MotoAmerica Technical Bulletin

01-5000-24 Yamaha R1 Connecting Rod Modification

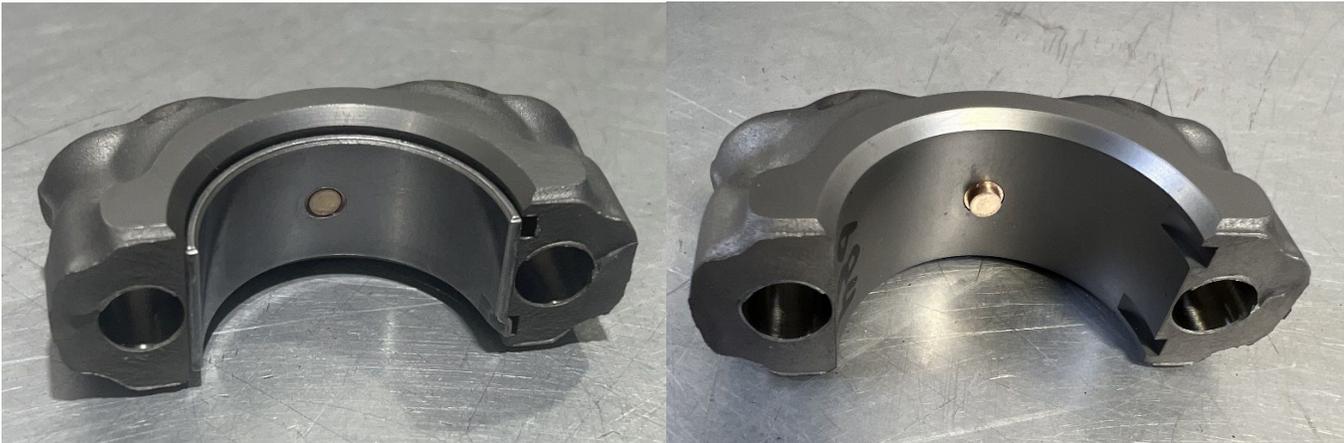
Allowance: Installation of a big end connecting rod bearing locating pin. The pin is installed in the rod cap (see pictures).

The allocation for Yamaha R1, aims to eliminate the rotation of rod bearings, to enhance the longevity of connecting rods. This process contributes to smoother operation, reduced wear and tear, and overall improved engine reliability.
